DELEGATED DECISIONS BY CABINET MEMBER FOR TRANSPORT MANAGEMENT

OXFORD: WOODSTOCK ROAD – PROPOSED PARALLEL CROSSINGS

Report by Director of Environment and Highways

ANNEX 2

Project Name: **General Arrangement RSAs**

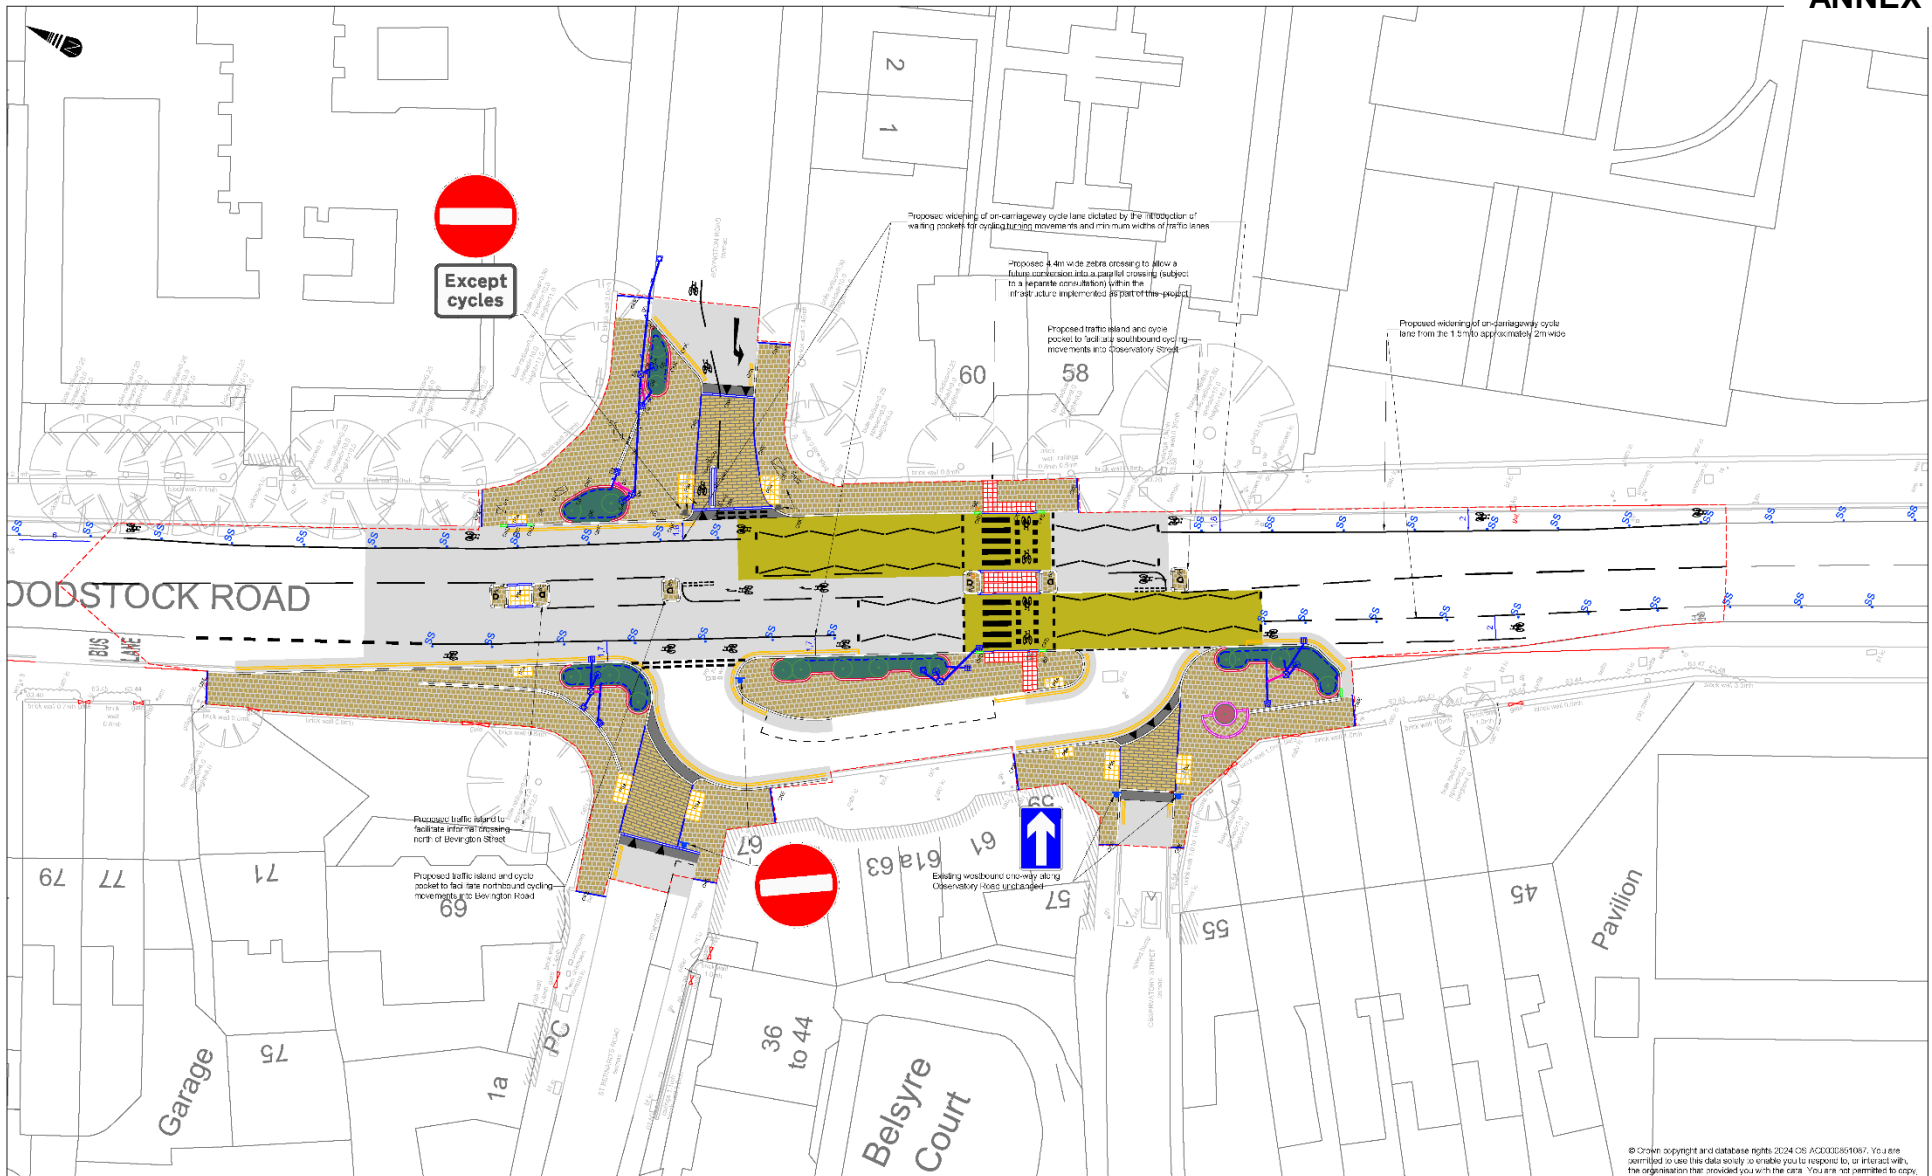
(3) County Cllr, (St Margarets division)	<p>Partially support – I have no objection to this proposal but note that southbound cyclists will also have a turning point in roadway to access Observatory Street. As the crossing is south of St Bernard's Road it will be useful for cyclists turning right if they are prepared to navigate the layby outside the shops rather than turn right from St Bernard's road. Is there any indication of the number of such cycle movements. The main use could be cyclists turning left from Bevington Road and wishing to cross to Observatory Street. I wonder whether the cycle crossing might be better placed further south for access to Green College and the ROQ roadway?</p>

4) Local group/organisation, (Walton Manor Residents Association)	<p>Object – The existing scheme makes provision for three traffic islands. They should all benefit cyclists and are indeed designed to do so according to the map. In addition to them there will also be a pedestrian crossing intended to help walkers wanting to cross the road to get to the shops and back etc. The text proposing the change to which this response relates talks rather grandly of the pedestrian crossing becoming a 'parallel crossing,' where seemingly pedestrians and cyclists will each have their own areas and hence (implicitly) won't wander into that part of the crossing which is not theirs. That's nonsense: people will cross where there is space to do so with some cyclists sticking to their area, some cyclists not knowing what they are supposed to do, and yet others just pushing in where they can.</p>

(5) Local group/organisation, (Oxfordshire Liveable Streets)	<p>Partially support – While it should work ok for pedestrians, the proposed parallel crossing is poorly located for cycle use. Cycling access on the west side could be sorted out (though it looks like passing directly behind a car parking space, which may create risks), but on the east side it doesn't really work at all. People cycling south on Woodstock Rd will need to do abrupt turns onto the crossing off the cycle lane, or stop in the cycle lane to wait, with their intention to cross not at all clear to drivers. And people cycling eastwards across the parallel crossing will have no way to get to Bevington Rd except by cycling "contra-flow" on the footway.</p> <p>A better solution here would be to close the "half-exit" of Bevington Rd, keeping it as a cycle route, and to shift the parallel crossing to be in line with that. This diagram shows a possible layout, with cycle movements in green and car movements in brown. As well as providing straight-on approaches to the cycle crossing, the pedestrian crossing would be on the desire line for Bevington Rd.</p>

(6) Local resident, (Oxford, Woodstock Road)	<p>Object – It is not needed. I am not aware of any accident history at this location. A central refuge will suffice.</p>

<p>(7) Local resident, (Oxford, Woodstock Road)</p>	<p>Object – I live in the terrace opposite the entrance to St Anne's. From your consultation document I see that you plan to remove the only vehicular access that currently exists to our house. We need vehicular access to our house because we have a Pellet Boiler which needs to be fuelled ever so often. A big tanker arrives here in those cases, which blows the pellets into their pellet storage. If you put plants where you are currently proposing to put plants according to your plan, this will not be possible any more. I'm sure you don't care in the slightest if I can heat my house or not, but actually it took me a lot of effort to get this house renovated in an environmentally friendly way and get some vaguely environmentally-friendly heating option in, instead of the gas that was still being peddled to us. An airsource heatpump was not possible because of the neighbours.</p> <p>I just want to cry about your plans and the fact that you are just going ahead already even though we've said something before. I'm all for trees, for bikes (I myself cycle everywhere) and for improvement to cycling in this town, but it is really necessary for town planning to understand that occasional vehicular access to a building is generally needed for maintenance purposes. You apparently propose to cut off three buildings from vehicular access.</p>

(19) Local resident, (Oxford, Sunderland Avenue)	Support – I support the parallel crossing but question why the zebra crossing cannot be made to the 10m max allowed by TSRGD. This should be the default width for all urban zebras.

18. One issue was raised around vehicle access, this will be resolved through direct discussion with the affected residents.
19. Another issue was raised over the previously agreed scheme, however this was addressed when approval was granted in July 2024.
